Bid Addendum Two

Project: **Tulip New Utilities Building**
Project No. Tulalip Tribes Project No. 2021-003

Date of Issuance: April 18, 2024

1
A4.11
JANITOR CLOSET - EAST WALL
Scale: 1/2" = 1'-0"

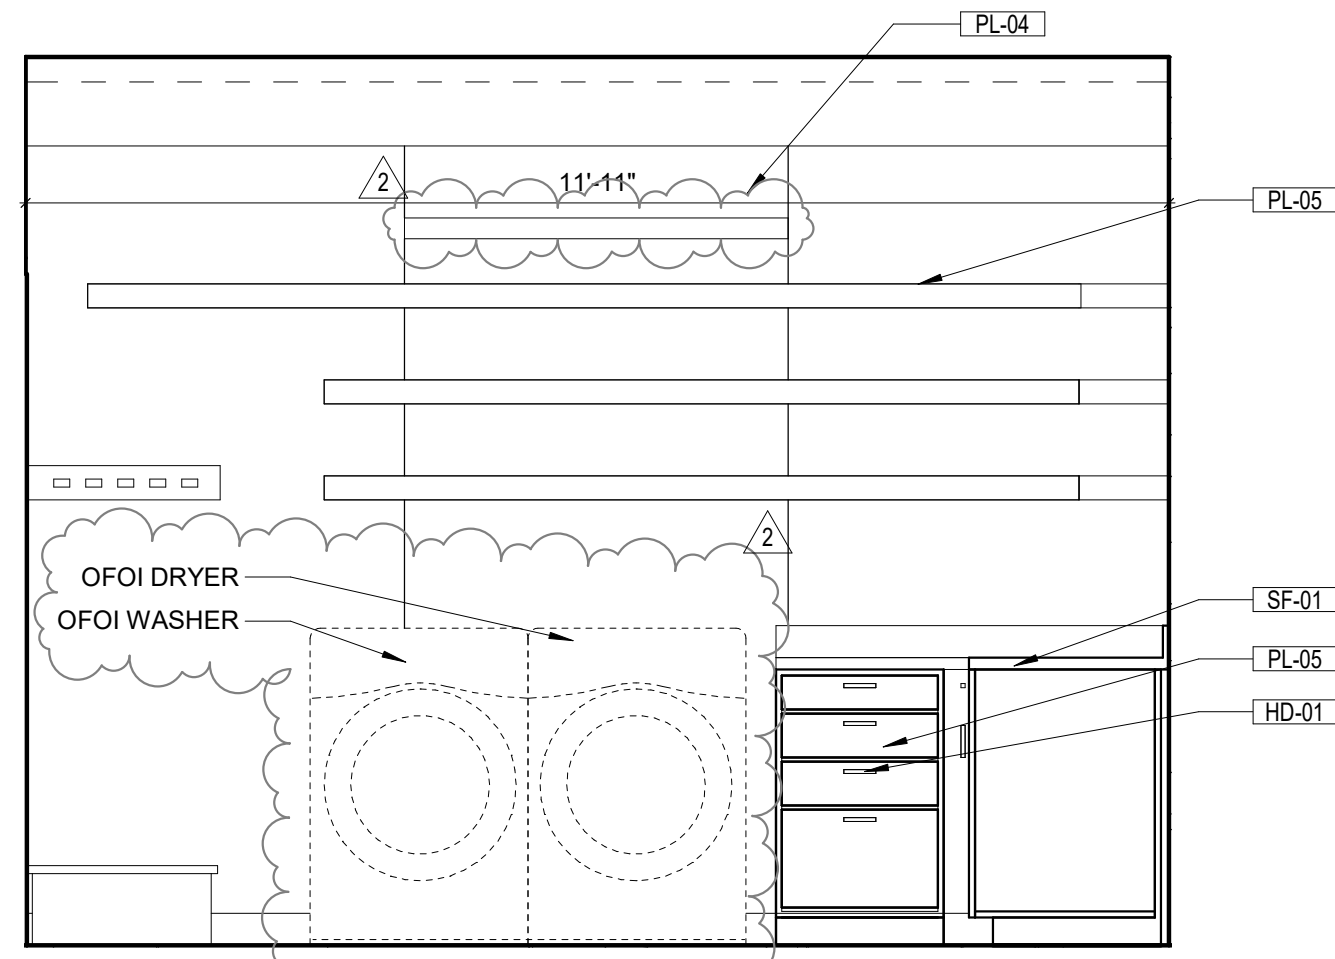
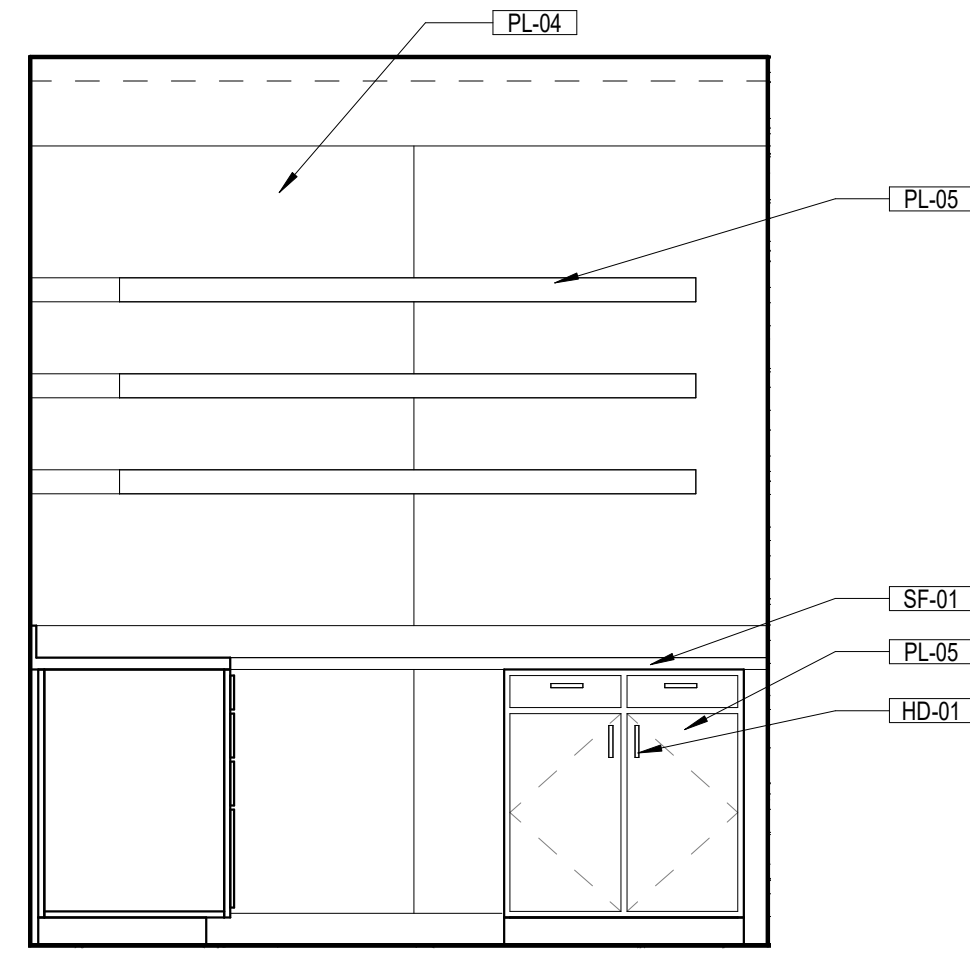
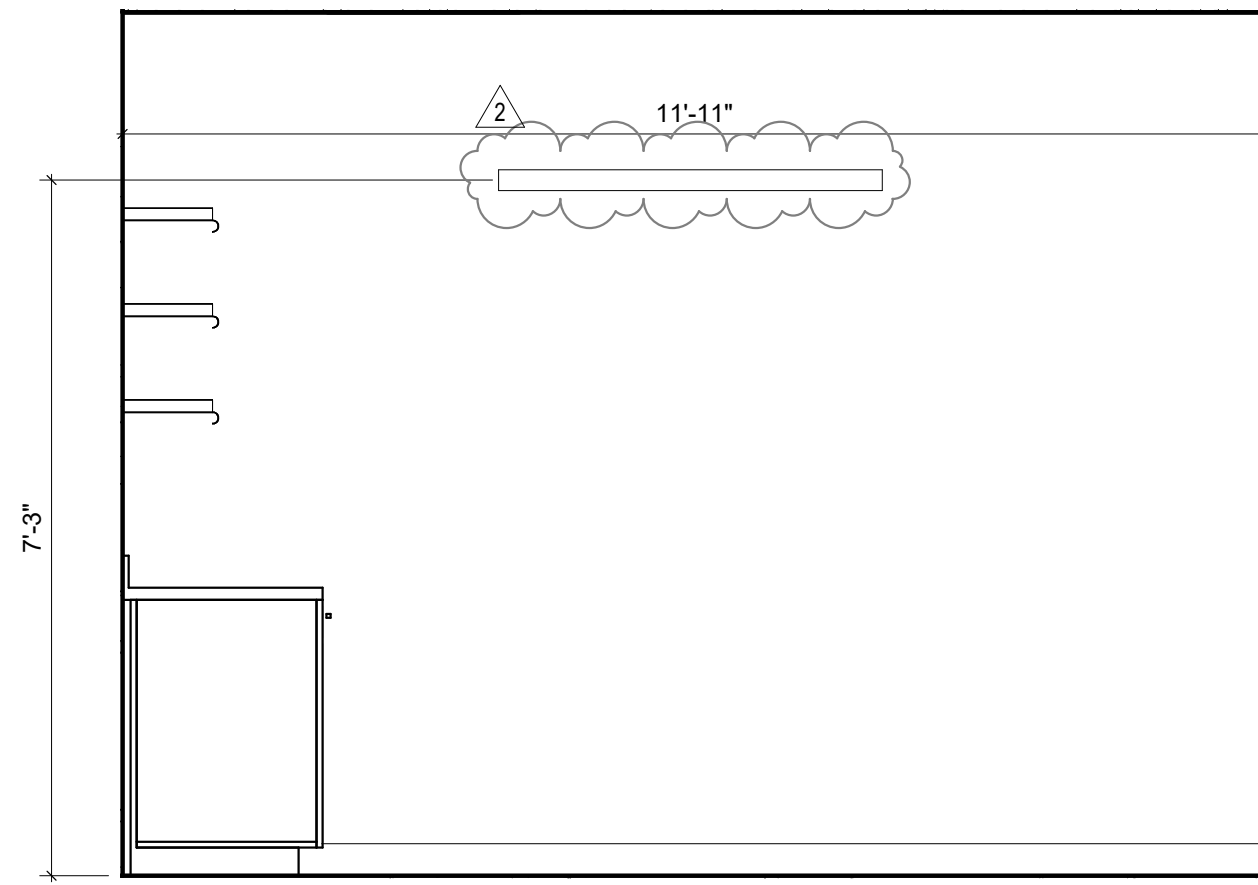
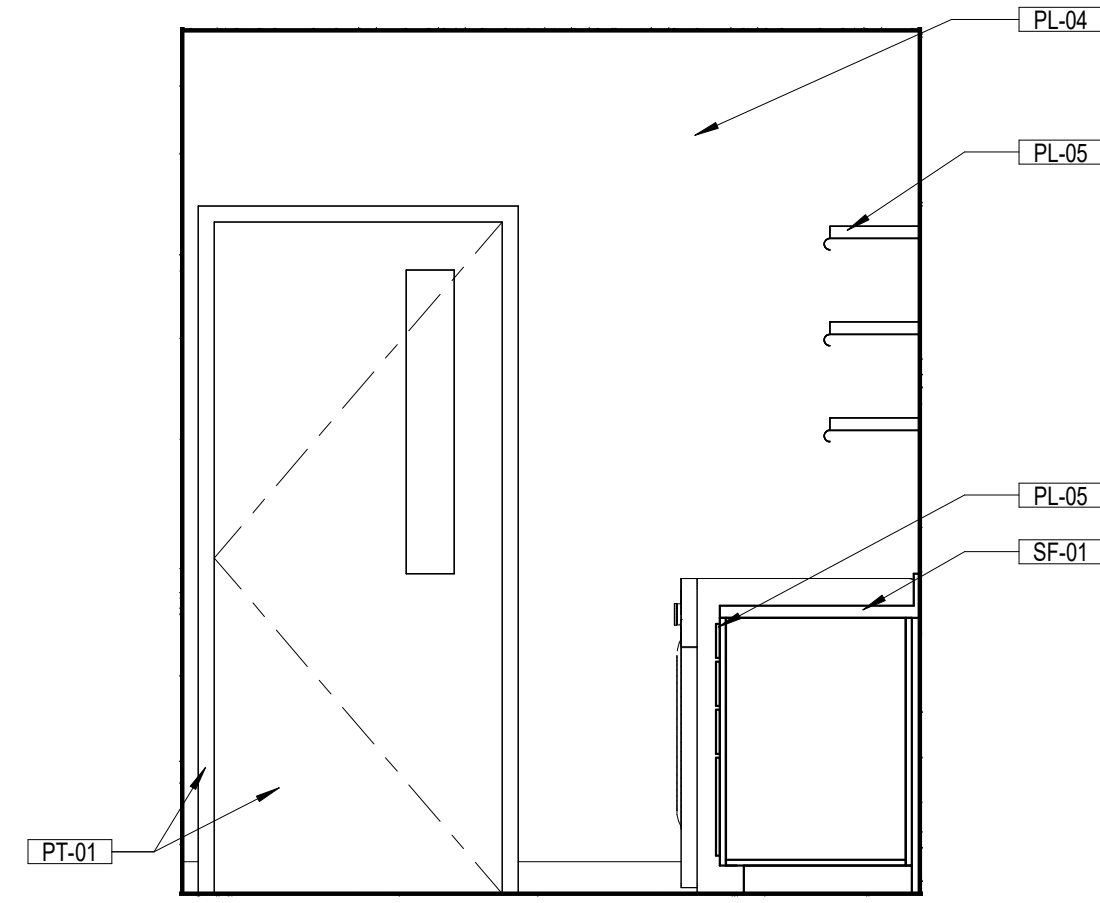
- A4.02 – addition of notes to lab casework.
 - A4.11 – change to light fixtures and clarification of washer and dryer as owner provided, owner-installed.

A7.00

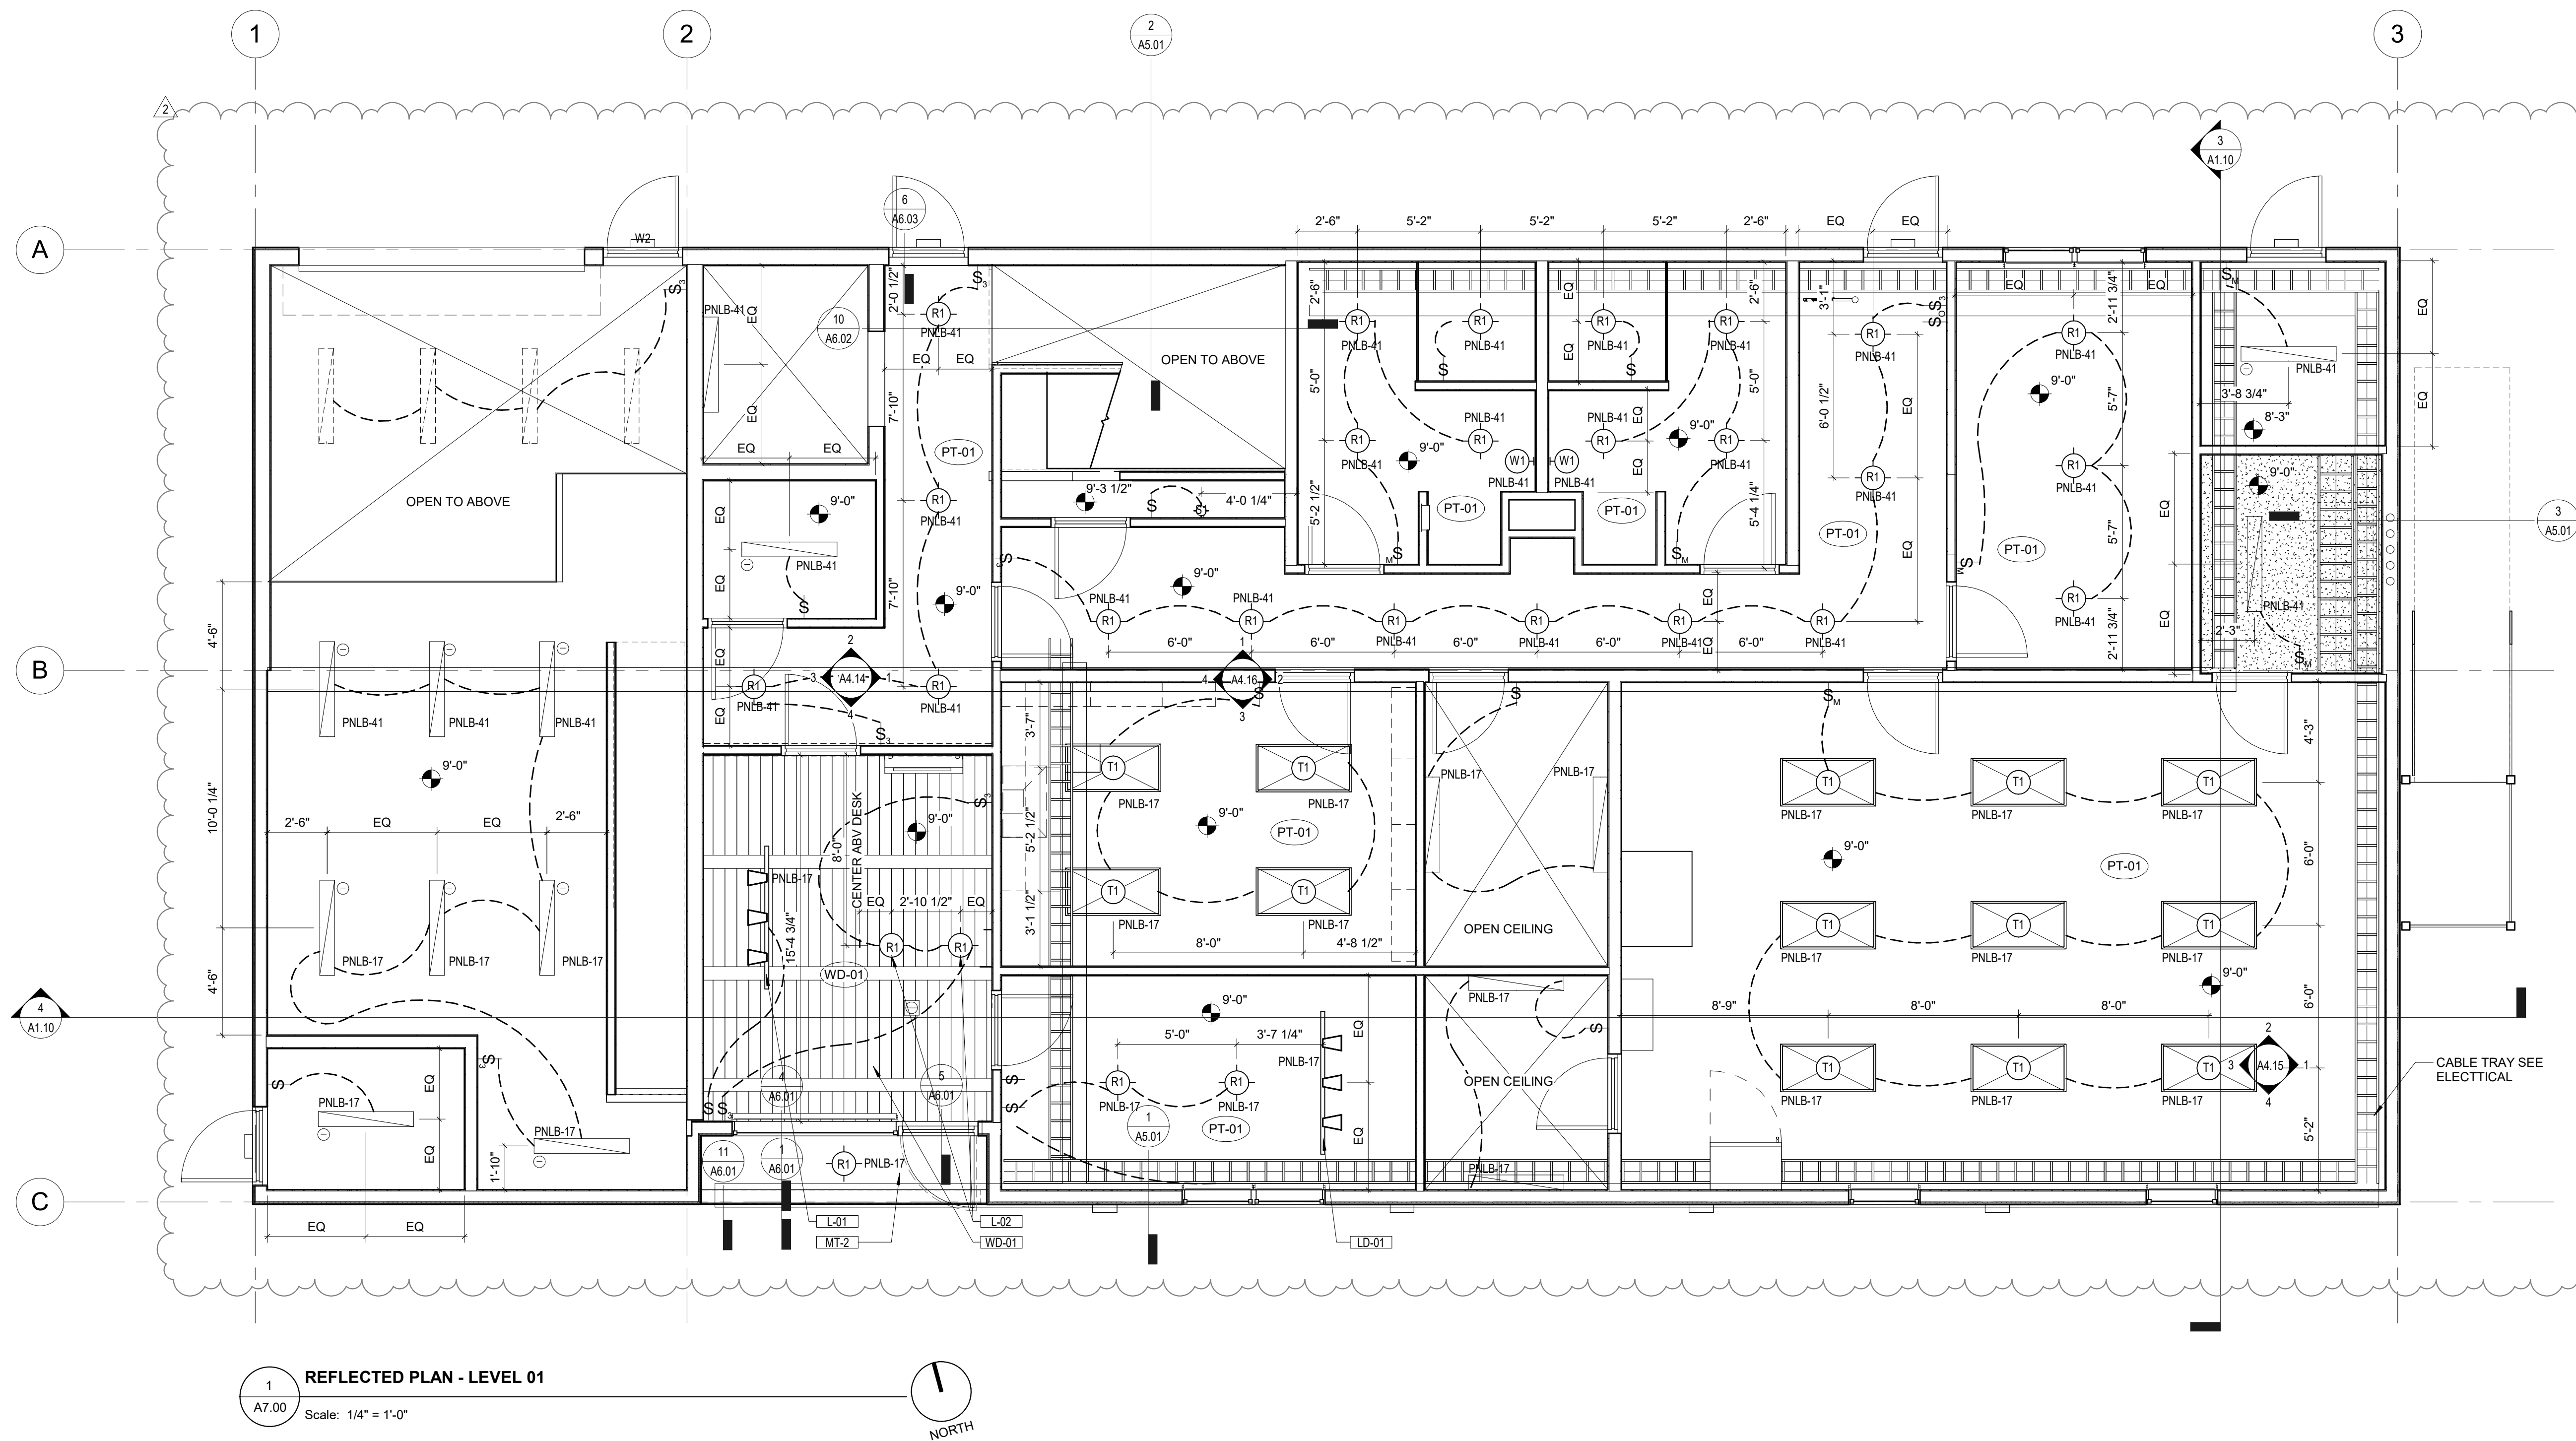
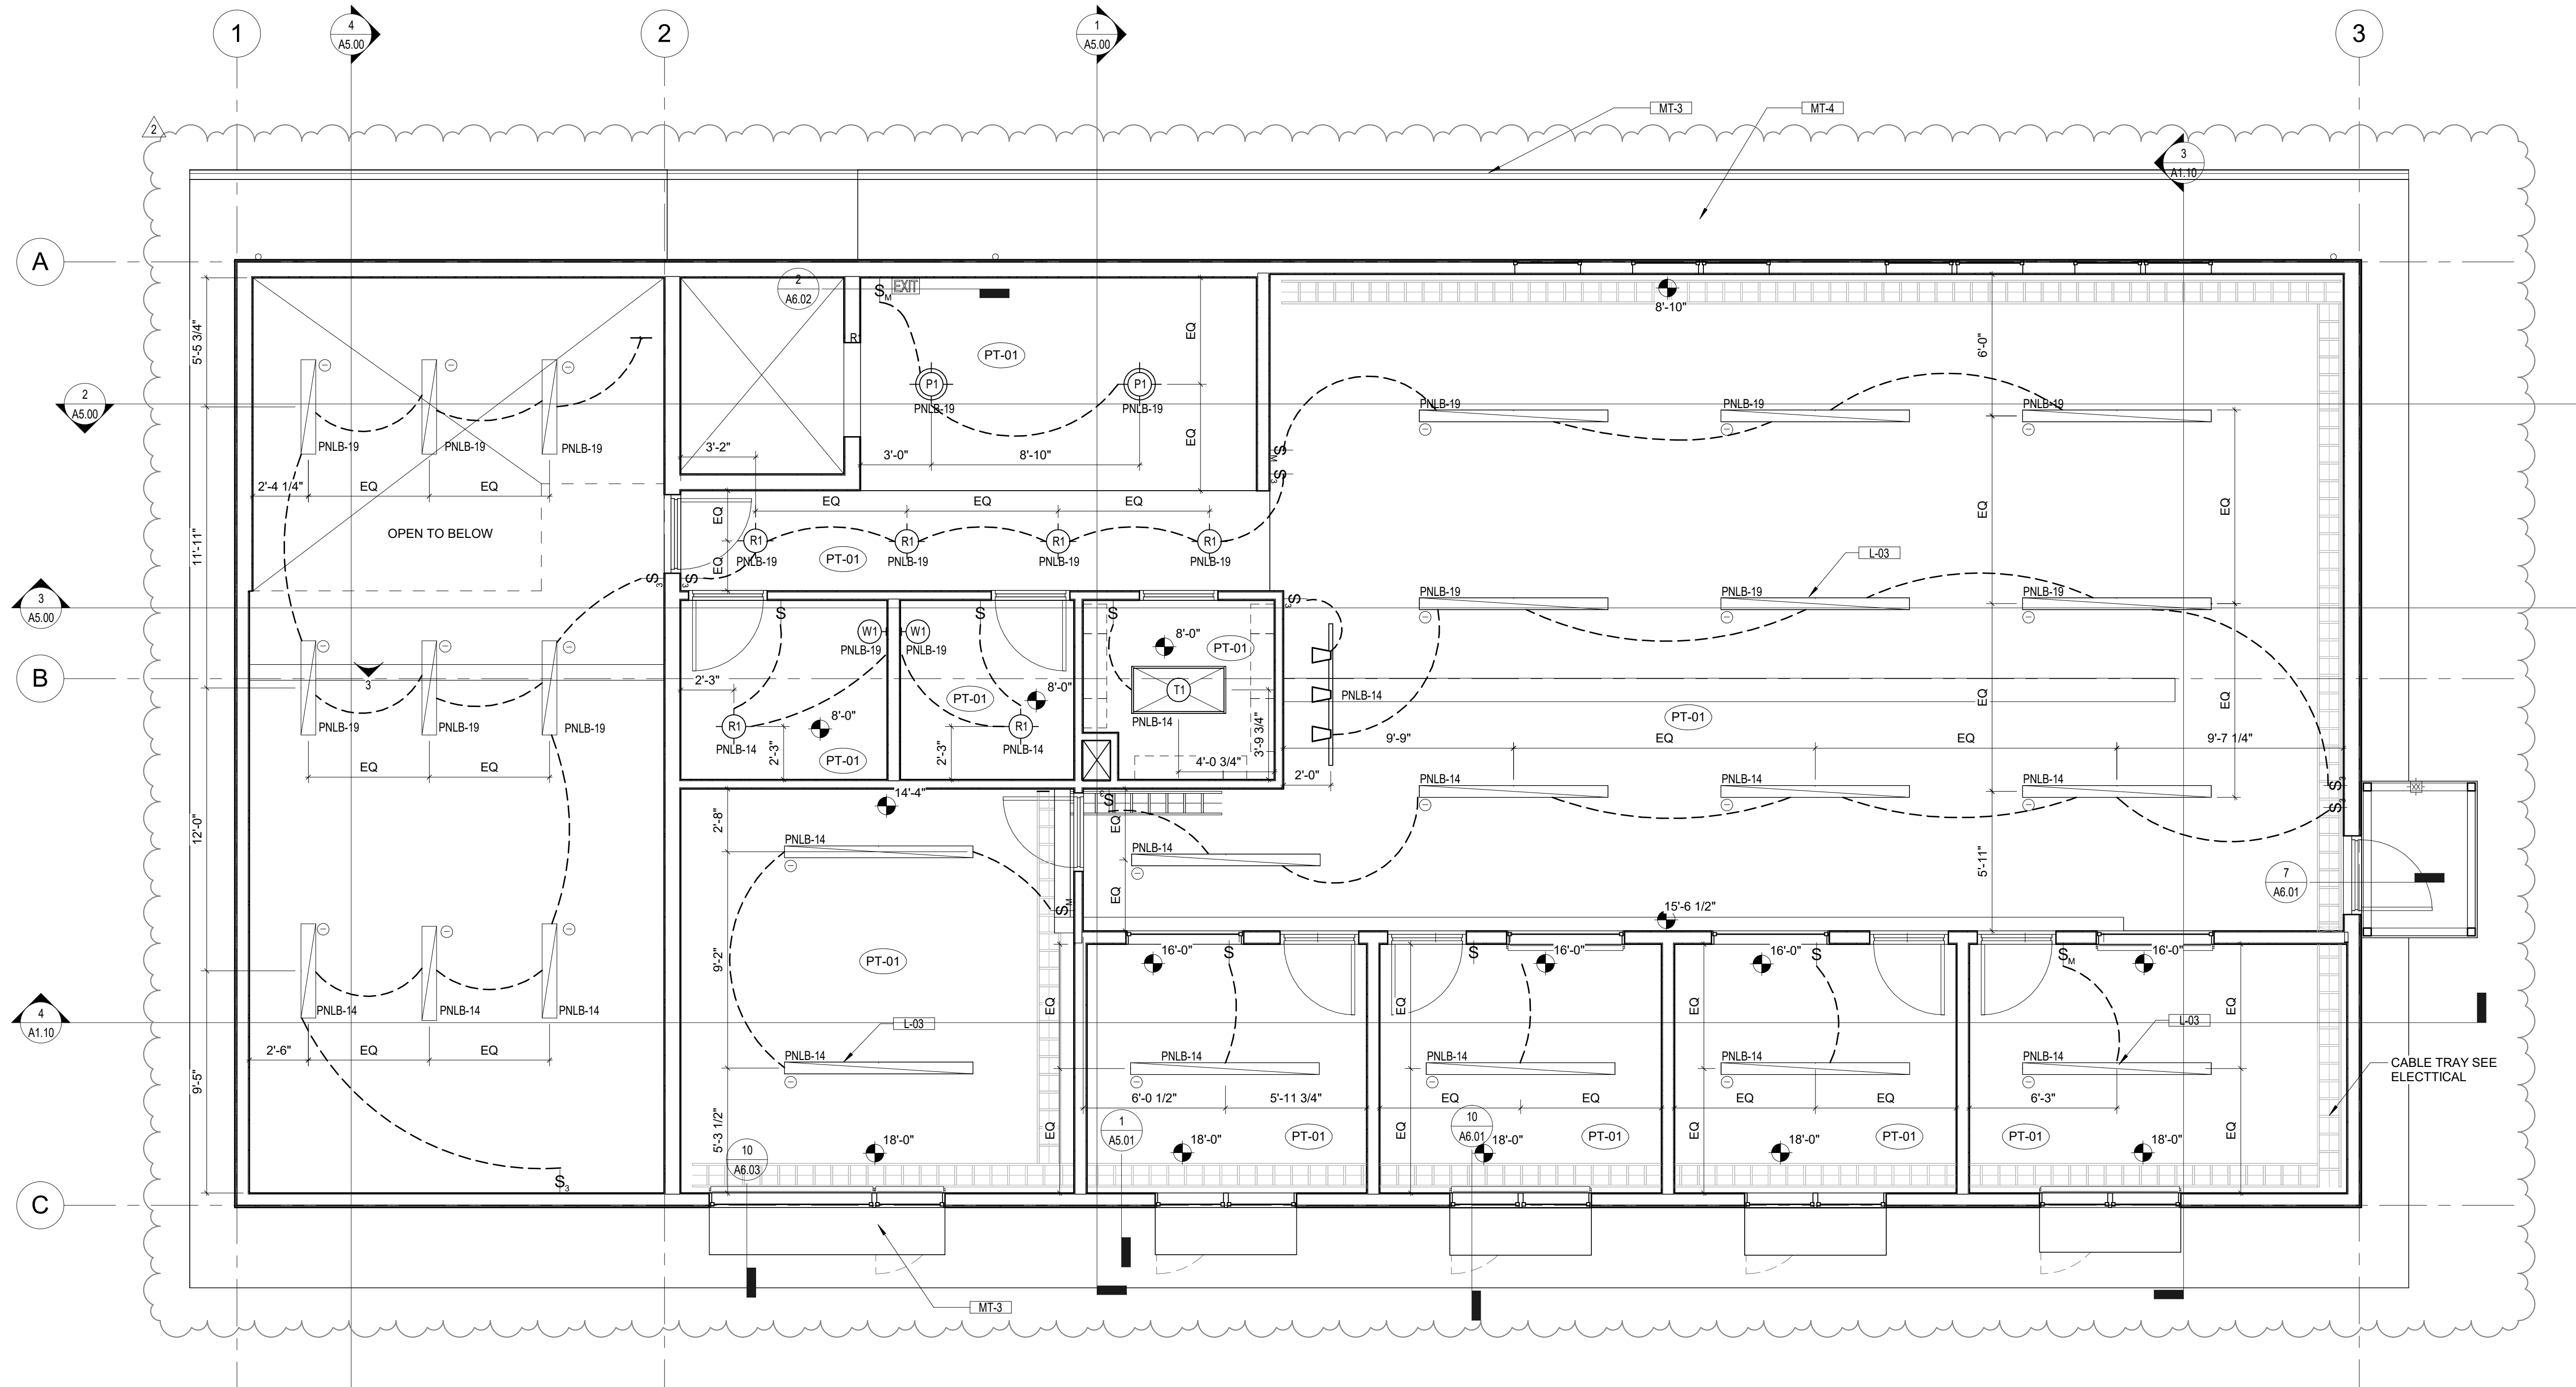
- A6.04 – addition of typical lab casework section, dtl. 11
 - A7.00 - Adjustment to RCP to agree with electrical
 - A7.01 - Adjustment to RCP to agree with electrical
